In the matter of an application by **Taggarts Earthmoving Limited**
for various resource consents for a quarry at Rangiora
Racecourse (**Racecourse quarry**) under section 88 of
the Act

And the submission of **The Rangiora Ashley Community
Board**

Evidence of Donovan Van Kekem

Dated: 27 April 2021

Figure 1 Site access road

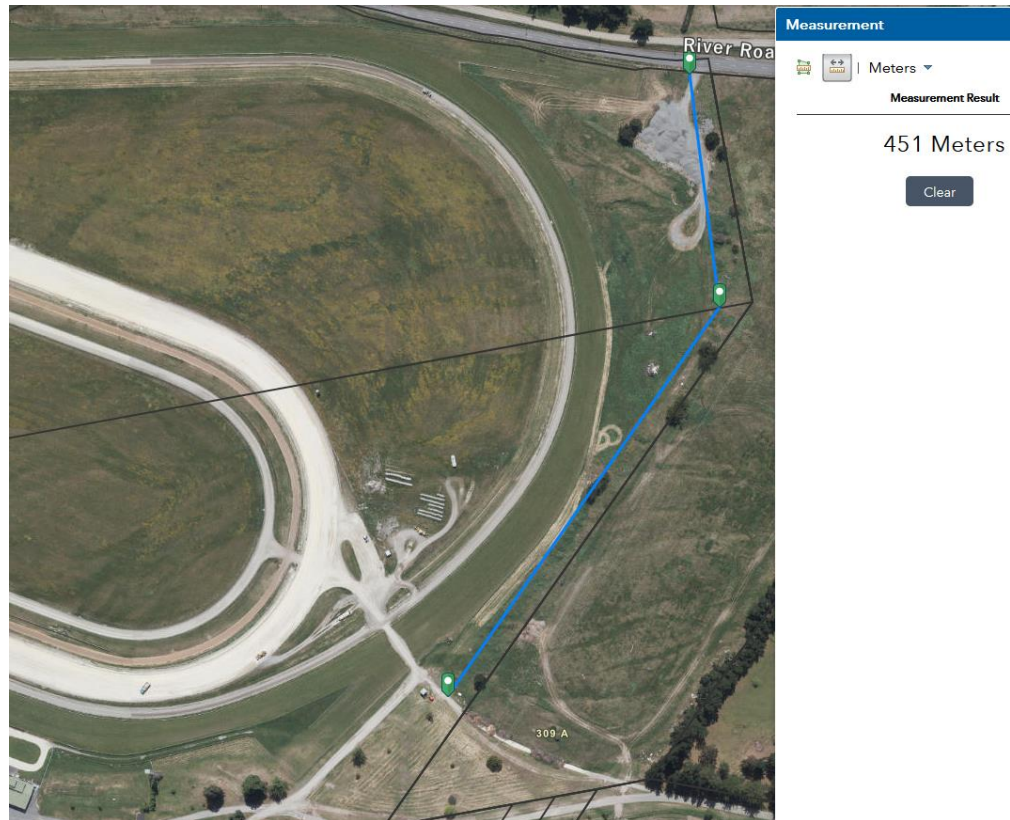
11. On Page 4 of the AQIA, PDP describe the site access road as being 140 m long with 50 m of this being sealed. These distances are also repeated in Mr Chilton's report and the evidence of Mr Bluett. By my measurement, the site access road would be approximately 450 m long (see Figure 1 below). This is if it runs along the eastern boundary of the site as described in the application and annotated in Figure 2 of the AQIA. In addition to this 'access road', from my understanding of the proposed staged aggregate extraction and VENM backfilling, there will also be internal haul roads which could be 700 m long or more. As vehicle movements on unsealed roads is often one of the primary sources of dust emission from quarry activities (in the absence of sufficient dust mitigation measures), the entire length and location of all unsealed site roads needs to be accurately described and assessed.

22. Therefore, as a minimum, I consider that this main access road should either be sealed in its entirety or be moved further from the airshed boundary. I note that Mr Chilton also recommends that it be sealed, but he shares the same inaccuracy about the length of the road (as discussed in Paragraph 11 above).

49. I also consider that as a minimum the whole site access road should be sealed (for its entire ~450 m length) or better still moved to a location more central to the site and further from neighbouring receptors/the gazetted airshed.

Figure 2 Distance to gazetted airshed

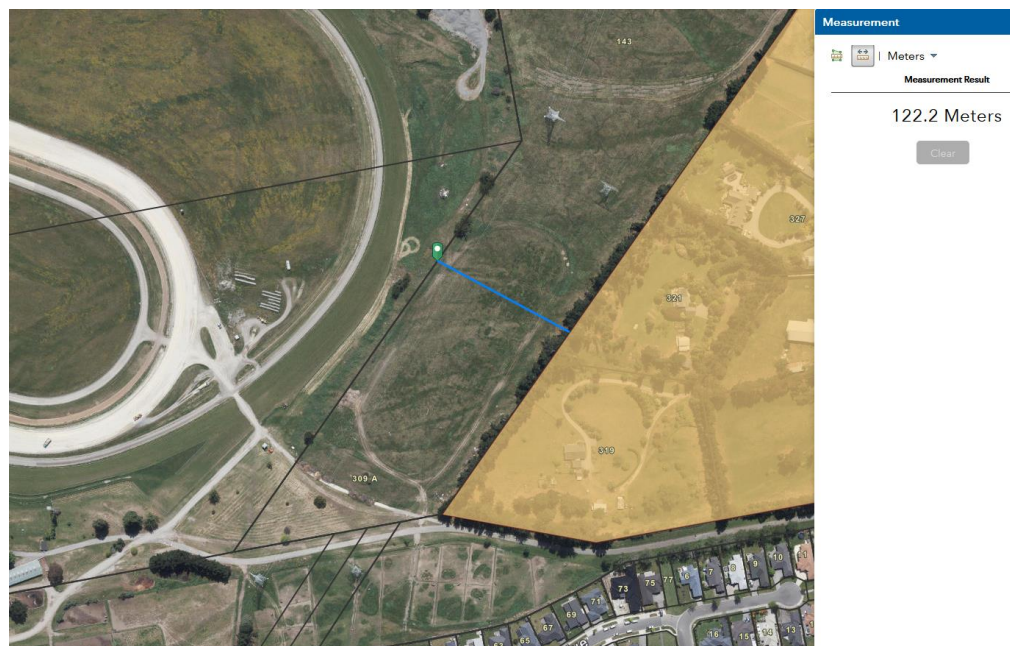
14. By my measurement, the main site access road will be approximately 120 m from the gazetted Rangiora Airshed (see Figure 2). On Page 41 of the AQIA PDP state that the airshed is approximately 200 m from the nearest dust generating activity, this appears to be incorrect. I consider that the main access/haul road, which is proposed to have up to 240 truck movements per day, will be one of the key potential dust discharge sources on-site. This inaccuracy in the separation distance between dust generating activities and the airshed is important for the issues raised in Paragraphs 15 - 22 below.

15. Regulation 17 in the National Environmental Standard for Air Quality (NESAQ) requires a consenting authority to decline an application for resource consent if the activity:
- "would be likely, at any time, to increase the concentration of PM₁₀ (calculated as a 24-hour mean under Schedule 1) by more than 2.5 micrograms per cubic metre in any part of a polluted airshed other than the site on which the consent would be exercised"*
16. The Rangiora airshed (highlighted yellow in Figure 2) is approximately 120m from the nearest dust discharging activity (the main site

access/haul road). This airshed is currently defined as 'polluted' as described in the NESAQ.
